DEPARTMENT OF THE AIR FORCE
HEADQUARTERS 377TH AIR BASE WING (AFMO)

1. Addendum to Final Interim Measures Work Plan (Shaw 2011)
2. Total Vapor VOC Plume Footprints
3. SVE Well Construction Diagram

**Subject: Soil Vapor Extraction Well Design, Location, and Installation
Interim Measures Work Plan, Bulk Fuels Facility Spill, Solid Waste Management
Units ST-106 and SS-111
Addendum November 2011
Albuquerque, New Mexico**

FIGURE 1

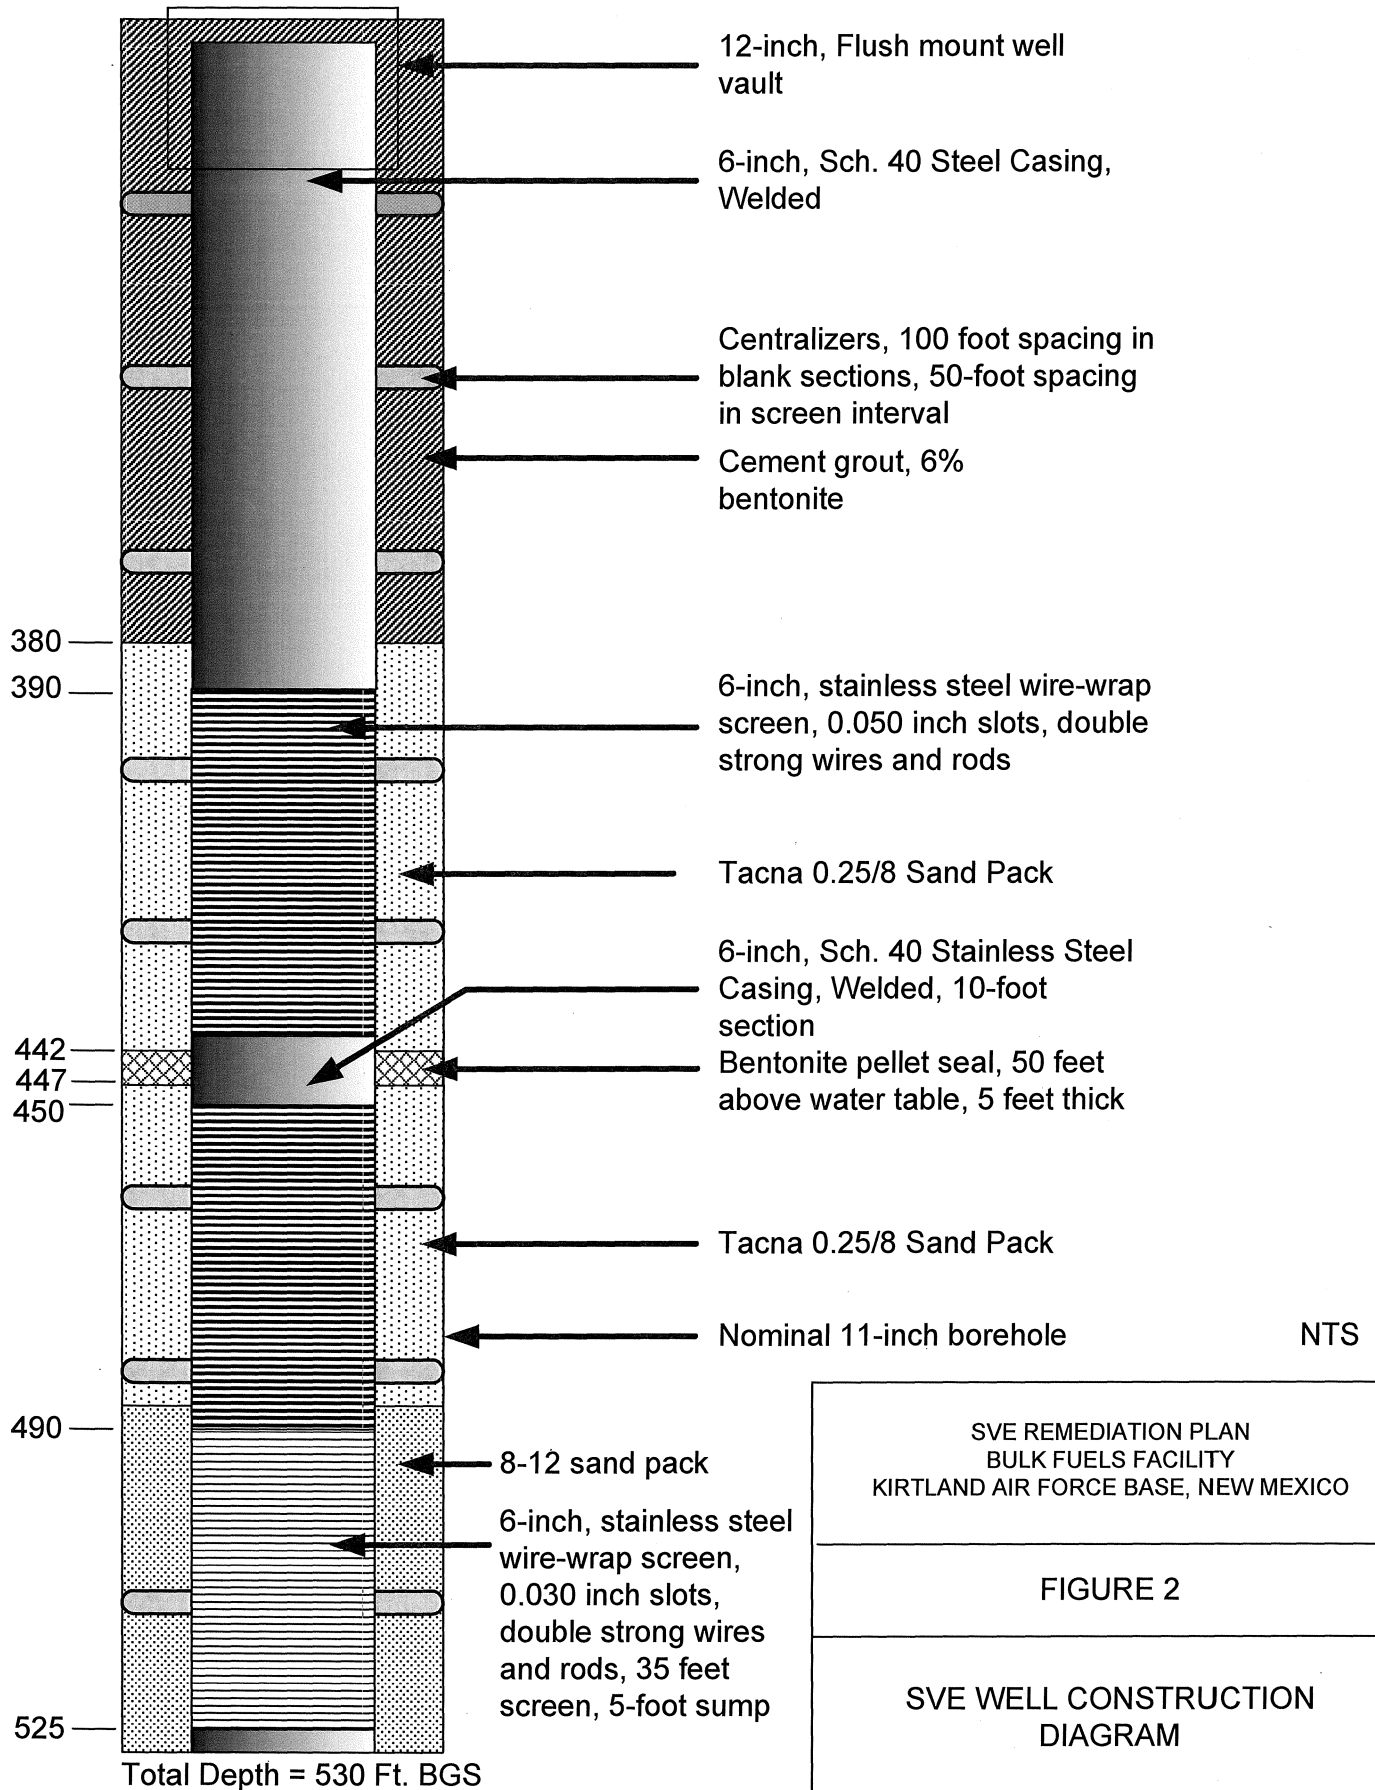
Figure 1, attached to this letter, shows the proposed locations of the two SVE wells, KAFB-106160 and KAFB-106161. Both wells are located on the installation and are within the region showing the highest concentration of vapor based on the results of Quarter 2 (April – June) 2011 data (Figure 1). The spacing of the wells is based on the vapor results, as well as a preliminary understanding of the radius of influence for soil vapor extraction units screened in the vadose zone.

**FIGURE 1
 LAB TOTAL VAPOR VOC PLUME
 FOOTPRINTS BY ELEVATION
 JUNE 2011**

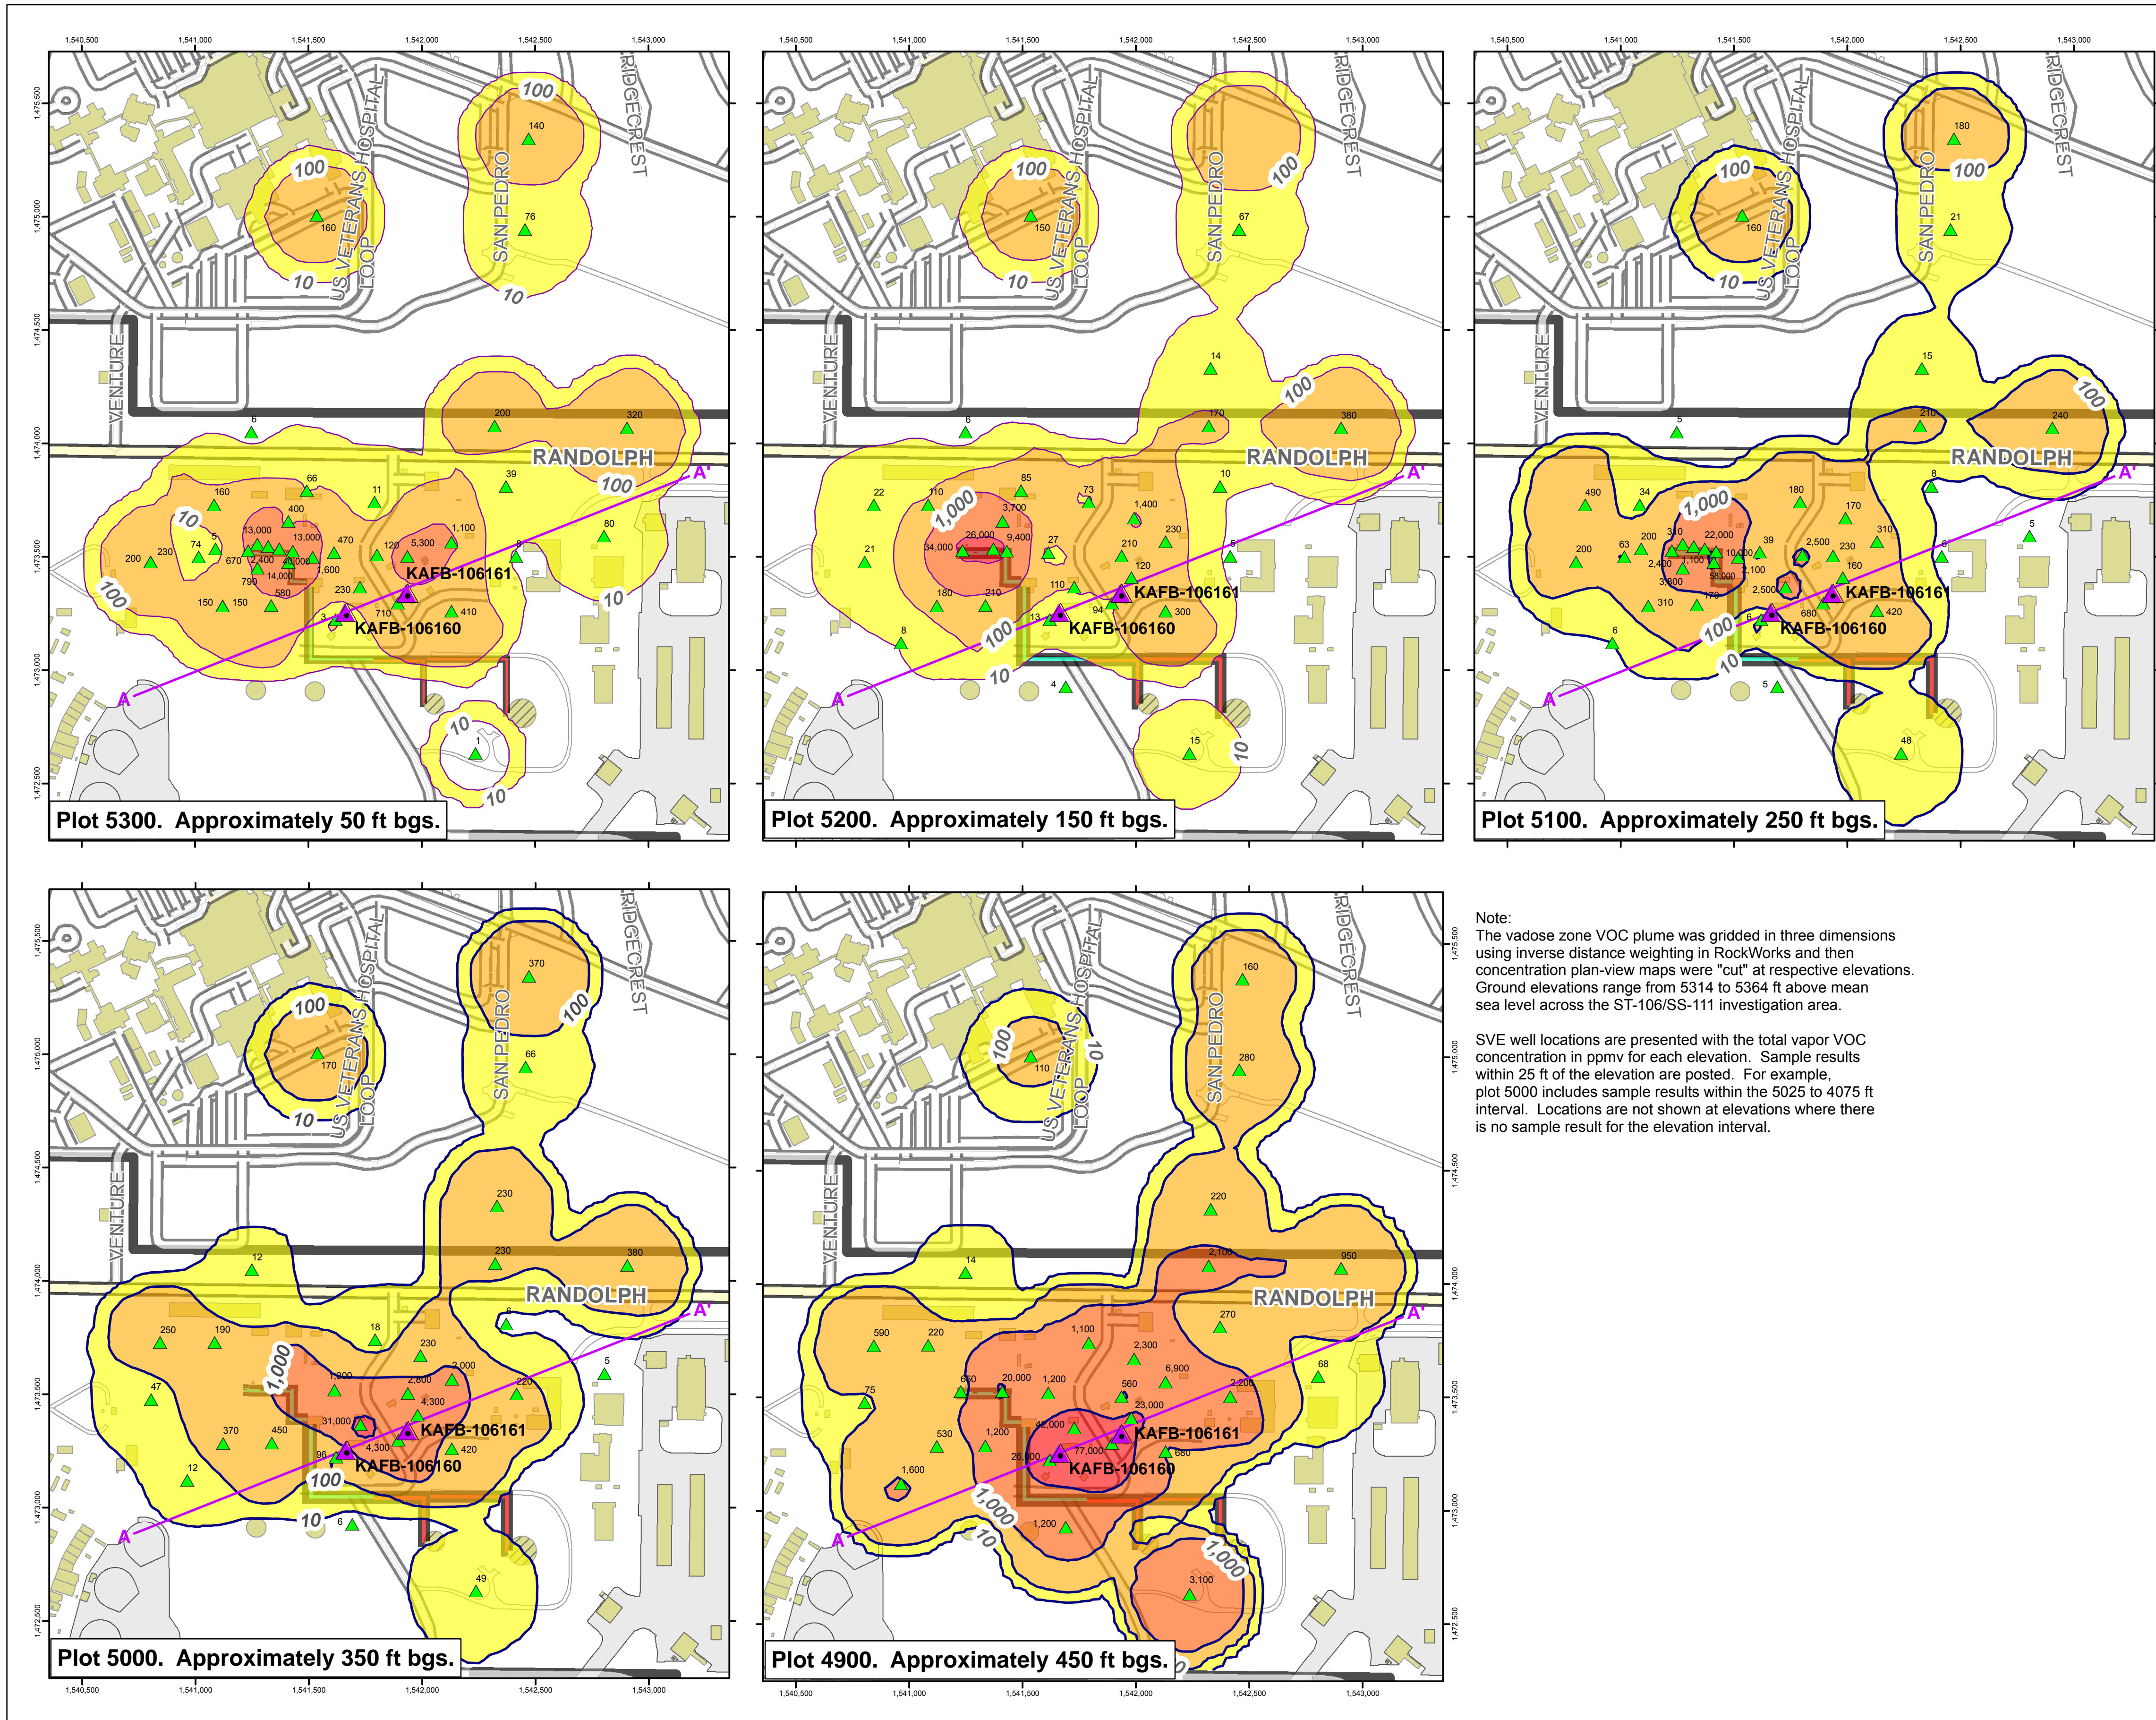
Figure 1, attached to this letter, shows the proposed locations of the two SVE wells, KAFB-106160 and KAFB-106161. Both wells are located on the installation and are within the region showing the highest concentration of vapor based on the results of Quarter 2 (April – June) 2011 data (Figure 1). The spacing of the wells is based on the vapor results, as well as a preliminary understanding of the radius of influence for soil vapor extraction units screened in the vadose zone.
